**Space systems — Test procedure to
evaluate spacecraft material ejecta
upon hypervelocity impact**

AMENDMENT 1: Oblique impacts and
Annex C update

Reference number
ISO 11227:2012/Amd.1:2021(E)

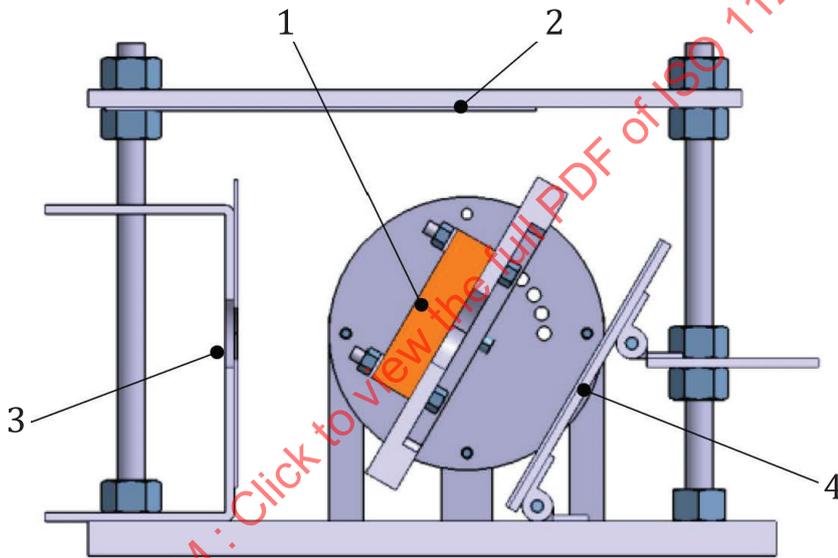
Annex C, d), first paragraph

Replace the first sentence with the following:

Recovery of intact fragments is possible using, instead of metal witness plates, a low-density material such as silica aerogel (see Figure C.5), or a soft material such as foam or cardboard.
